**Submission for Compliance with Approval Condition (a)  
– the Submission of a Drainage Proposal**

**Proposed Temporary Place of Recreation, Sports or Culture (Hobby Farm)  
for a Period of 5 Years and Filling of Land in “Agriculture” Zone, Lots 1058 RP,  
1059 RP, 1060 and 1061 in D.D. 107, Fung Kat Heung, Kam Tin, Yuen Long**  
**(Planning Application No. A/YL-KTN/806)**

**Appendix I – Response to Comments of the Chief Engineer/Mainland North, Drainage Services Department (CE/MN, DSD)**

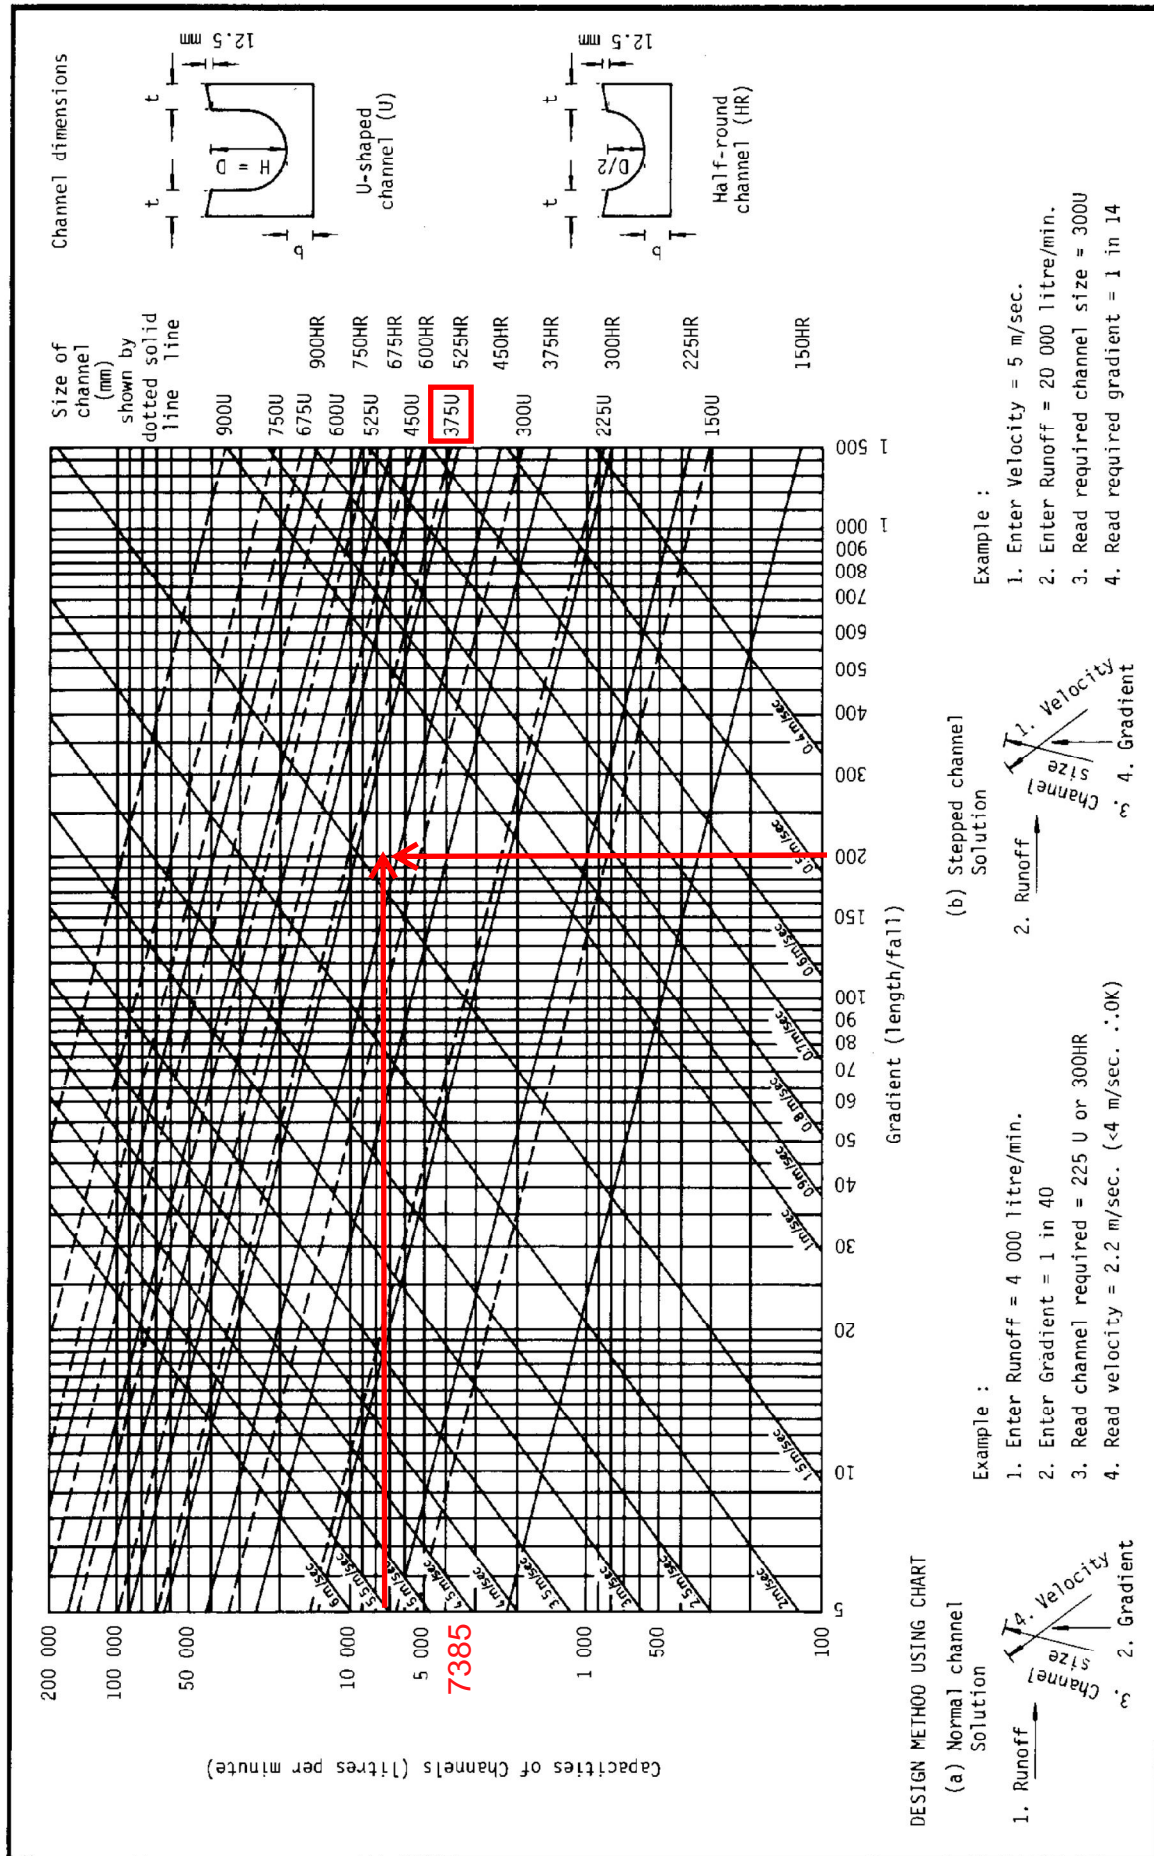
<b>Comments of the CE/MN, DSD (Contact Person Mr. Terrence TANG; Tel: )</b>		
(i)	SDM corrigendum nos. 1/2022 and 1/2024 should be considered in the assessment. Please consider to upgrade the drain size.	Noted. SDM corrigendum nos. 1/2022 and 1/2024 are followed, and the drain size is also upgraded accordingly ( <b>Appendix II</b> ).
(ii)	According to the SDM, the impact of a 50-year event should also be assessed.	Noted. A 50-year return period is also adopted in the proposal ( <b>Appendix II</b> ).
(iii)	Sediment reduction should be considered in the assessment.	Noted. Sedimentation is also considered in the proposal ( <b>Appendix II</b> ).

Calculation of Runoff from the Proposed Development,

$$Q = 0.278 * 0.95 * 295 * 0.001362 * 1.16 \text{ (16% for rainfall increase due to climate change)}$$

Therefore, design V of pipe capacity	=	2.4459	m/s	<	3	m/s	
Capacity of pipe	=	VA	=	3.14*0.175*0.175*2.6646			
	=	0.173	m <sup>3</sup> /s				
Apply 0.9 factor for sedimentation	=	9336	lit/min	>	7385	lit/min	OK
